LERA

Re: Response to Letter Requesting Additional Information from the Millennium Tower Homeowners Association

As requested in your August 23, 2018 letter to Mr. Vision Winter, we are providing you with additional clarification regarding the basis of our opinion about the safety of the existing building foundation for the Millennium Tower at 301 Mission Street on behalf of the Millennium Tower Association. For clarity, we've repeated your questions in bold and followed with our answers.

Figure 15. Individual Pile Lateral Stiffness / Capacity – Compression Axial Load Variation with Shear Capacity

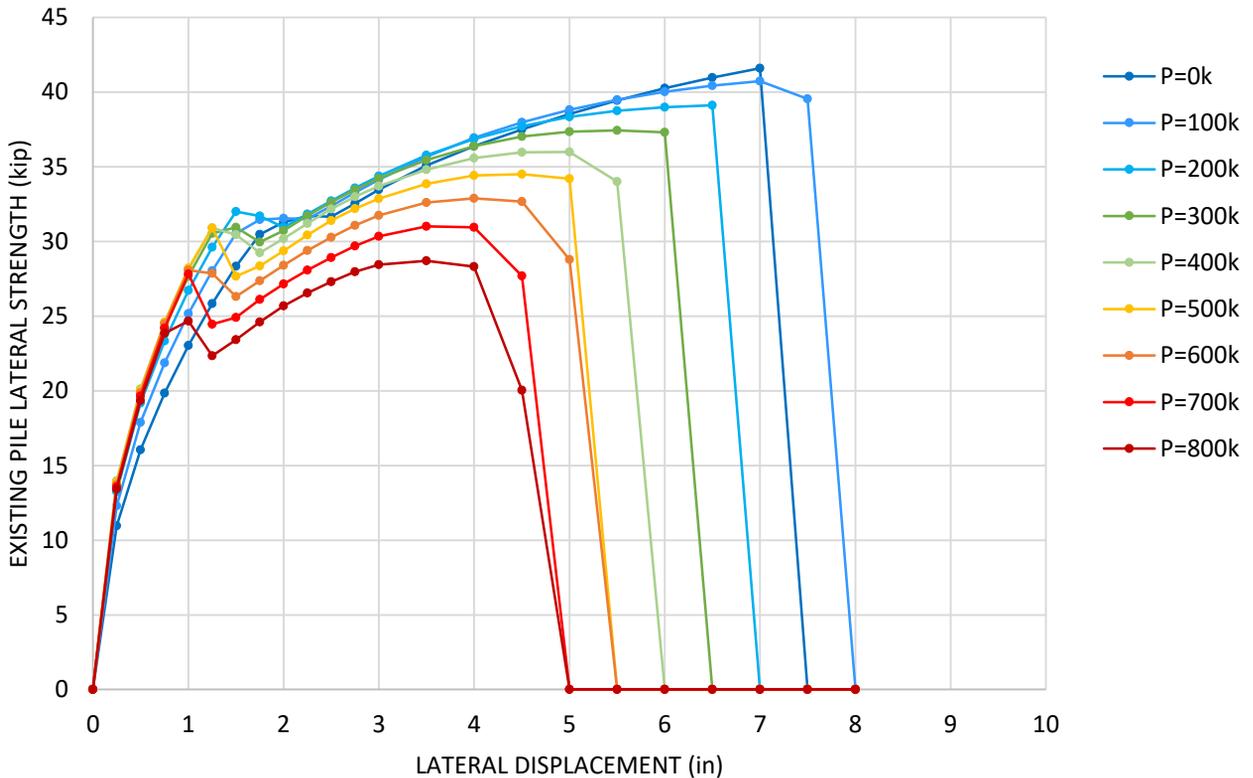
- e. Confirm whether the shear capacity of the piles has been checked to ensure that shear failure does not occur before hinge formation in the piles.**

Confirmed, the pile structural shear capacity exceeds the maximum lateral force resistance for all values of axial load. See Figures 15 & 16.

Figure 17. Passive Soil Resistance to Lateral Loads

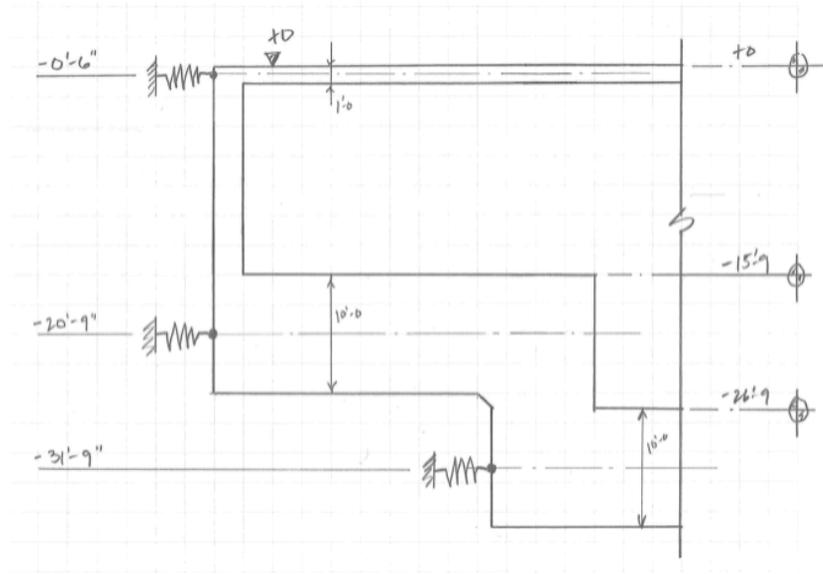
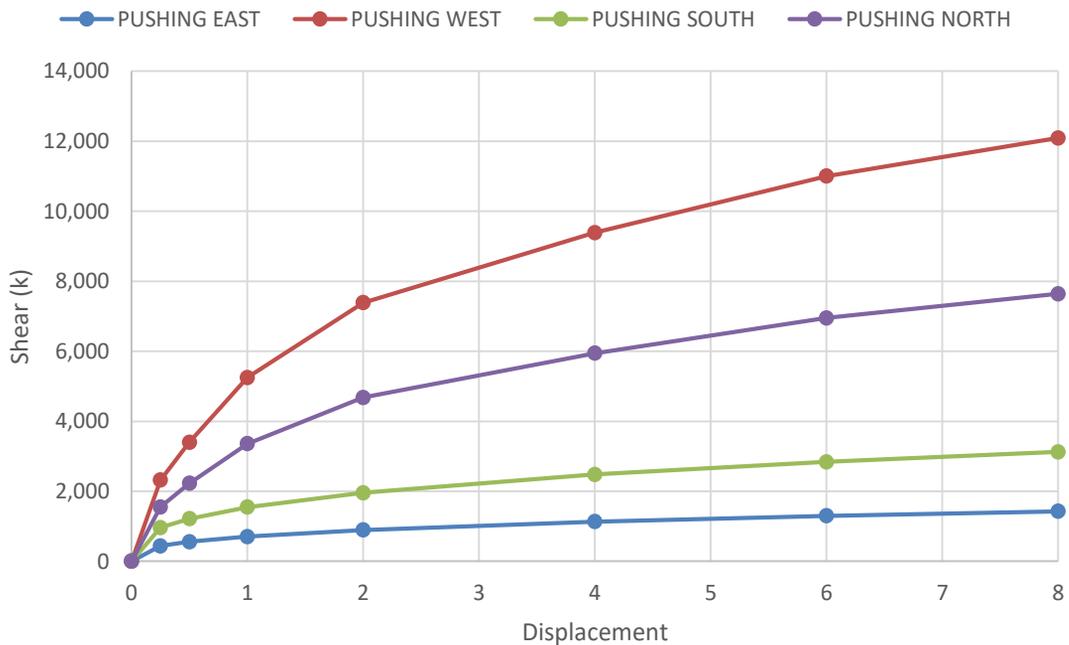
- a. Provide a description and/or diagram to illustrate how the foundation and surrounding soil are represented in the nonlinear structural analysis model (ETABS) and where the ground motions are introduced into the model.**

Passive pressure is modeled using compression only nonlinear springs. See Figure 17.

**Figure 18. Nonlinear Time History Analysis Results
Excluding Earth Pressures**

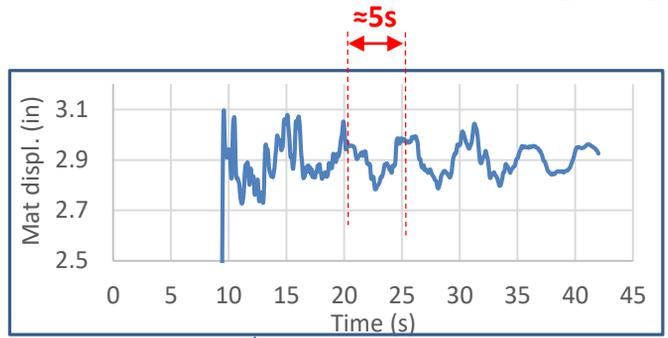
c. Rerun and report results from nonlinear dynamic response under BSE-2 ground motions where the active earth pressure and unbalanced soil stiffness are ignored (i.e., ignoring the soil above the base of the mat on all sides of the building). This is important to provide a more direct comparison with the SGH analyses.

See Figure 18. We found 4 non-convergences out of the 11 ground motions when earth pressures were ignored.

**Figure 19. BSE-1N (2/3*MCE) NLRHA Results –
Mat Oscillations**

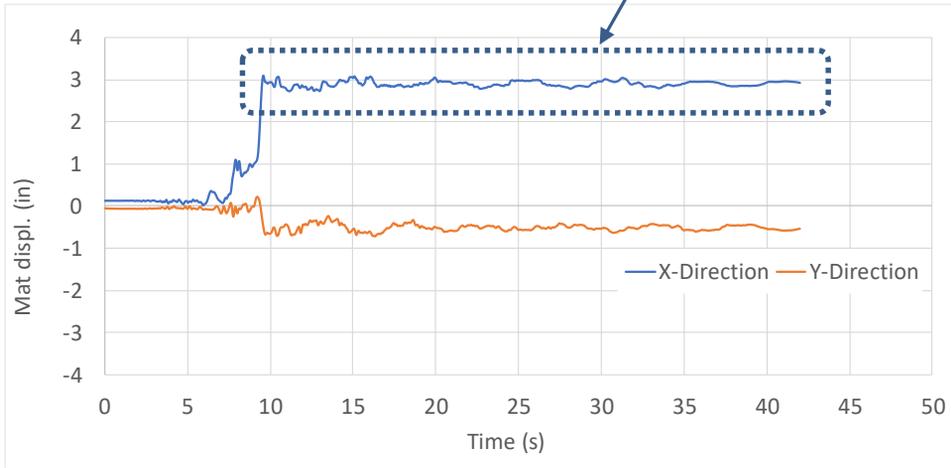
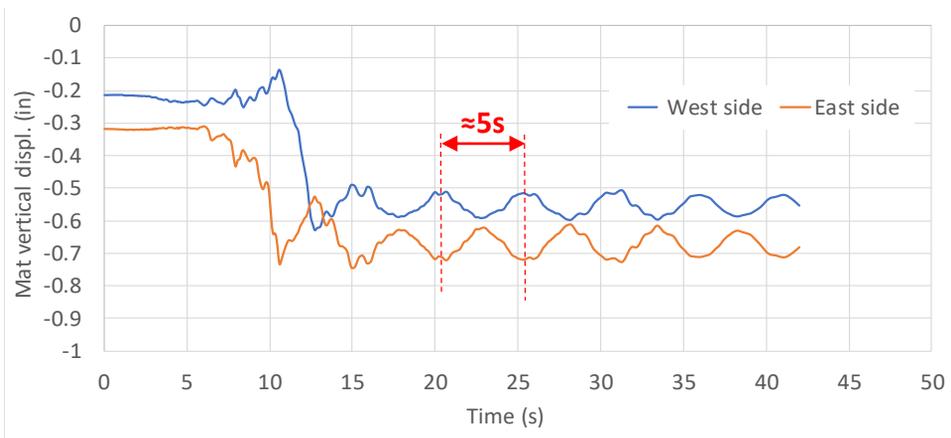
- a. As shown in Figure 27, the mat will have small lateral movement in the X-direction until about 9 seconds, when the displacement jumps to 3 inches, but then there are no oscillatory lateral movements beyond 9 seconds. In contrast, it appears the vertical displacement has oscillations after 12 seconds with a period of about 5 seconds (period of the structure?). Please explain the underlying horizontal and vertical mechanisms that can lead to the differences in the horizontal and vertical response histories.**

The apparent difference is due to the different scaling of the graphs. When the displacement plots are evaluated at the same scale, we find that the lateral movements have oscillations similar to vertical displacement. As you note, the period of these oscillations is about 5 seconds which is close to the periods of the 1st and 2nd mode of the structure - 4.67 and 4.53 seconds respectively. See Figure 19.

Figure 20. Representative Pile – Hysteretic Response

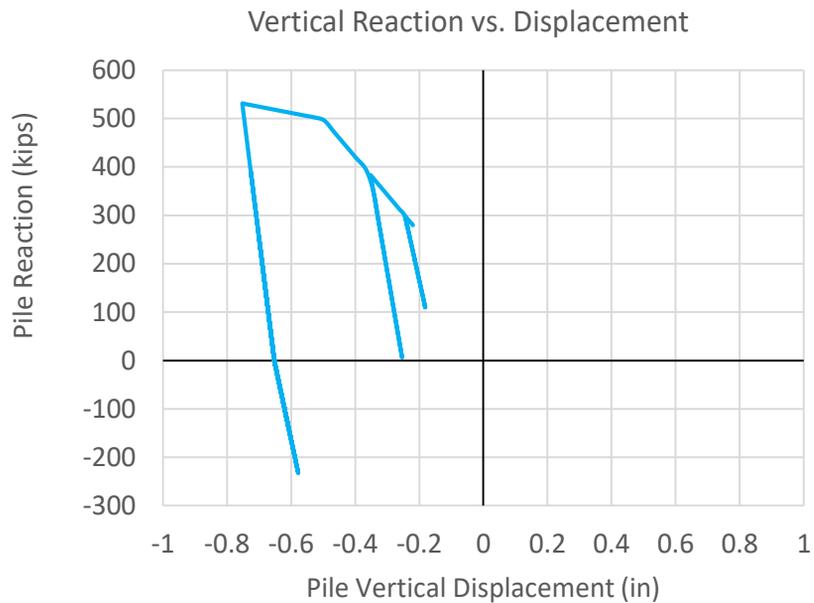
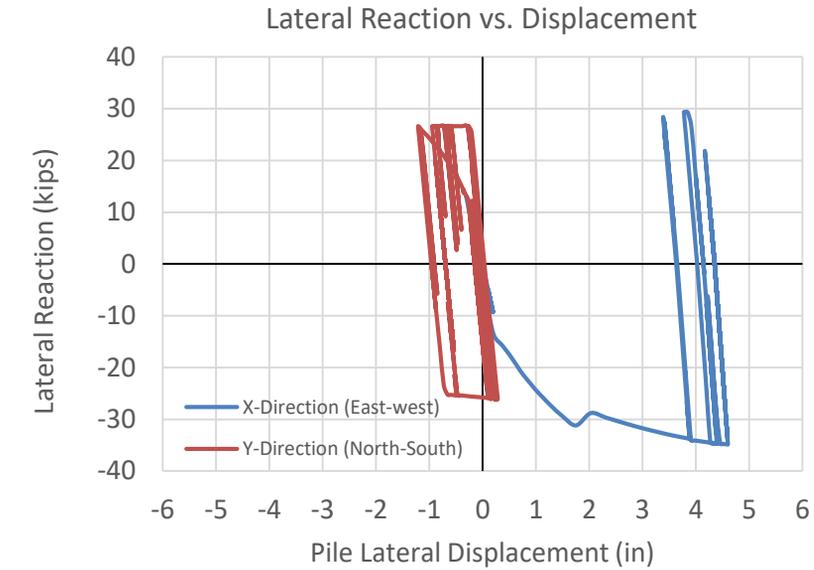
- b. Provide hysteretic response plots of the horizontal force-displacement and vertical force- displacement for one or more representative piles. Also, clarify how unloading response is modeled in the piles.**

For both horizontal and vertical resistance, the piles are modeled as Multilinear Plastic links with isotropic hysteresis type in ETABS. Unloading occurs along a path parallel to the initial elastic stiffness.

See Figure 20 for representative hysteretic response plots for both horizontal and vertical motions.

Figure 21. BSE-1N (2/3*MCE) NLRHA Results – Residual Building Drift

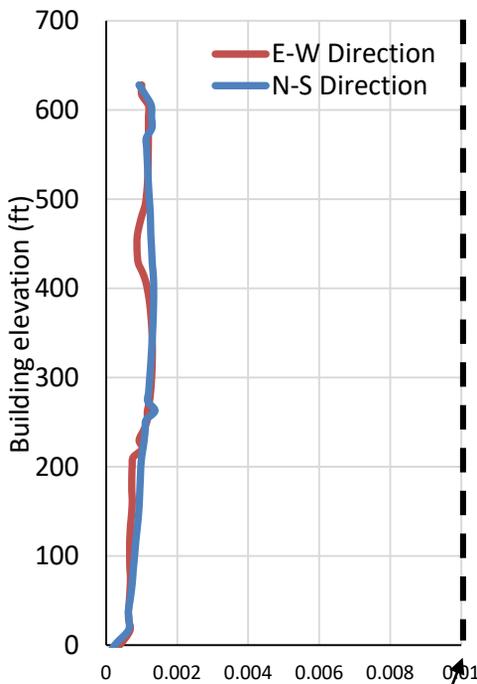
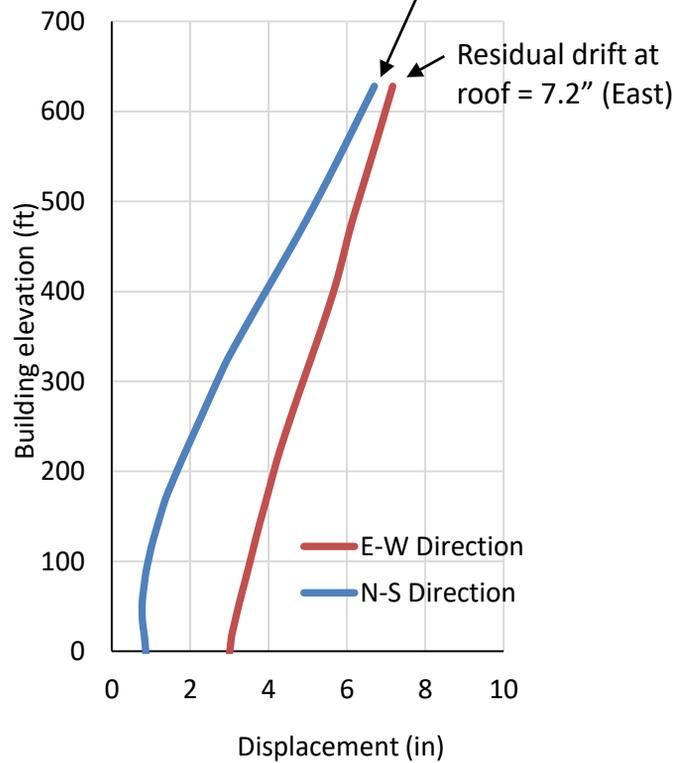
- c. Confirm whether residual building drift will result from the vertical mat displacements in the BSE 1 and BSE 2 ground shaking.**

Yes, residual drift will result. See Figures 21 & 22.
